Mr. BINMAN

Reg No: W0061-03

Re: Notice in accordance with Article 14(2)(b)(ii) of the Waste management (Licensing) Regulations

With reference to the above waste licence review application, please find below a response to the further information requested in your Notice dated 30th November 2009.

Figure 1: WWTP Effluent BOD Trend

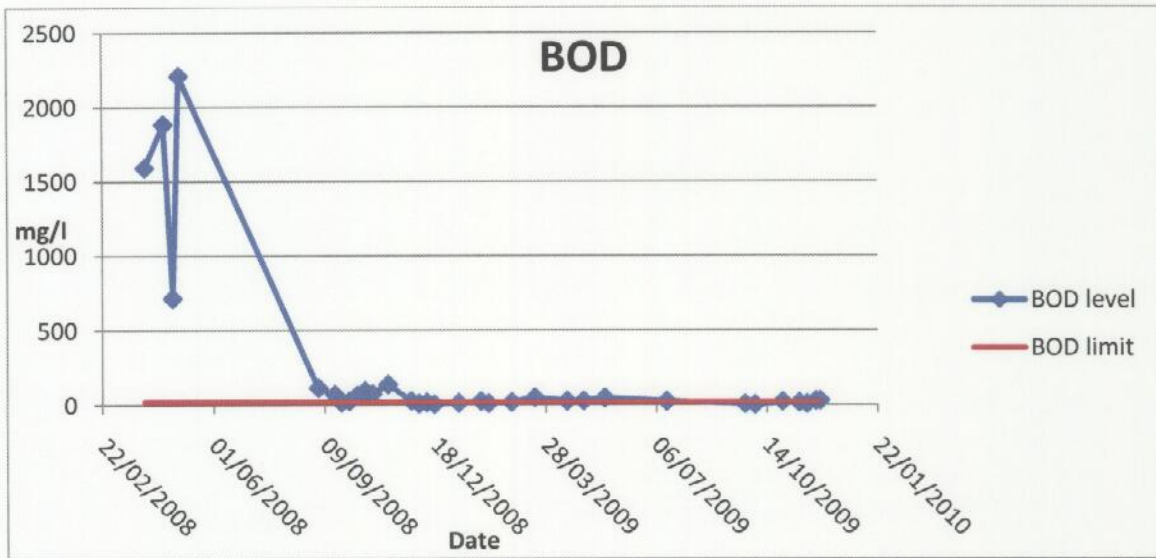
As a result of the improvements listed above, the quality of the effluent has improved significantly in the last 18 months. This improvement can be demonstrated by referring to the measured effluent BOD, suspended solids and pH data and trends (see below) in the past 18 months which clearly shows the plant has improved significantly during that period.
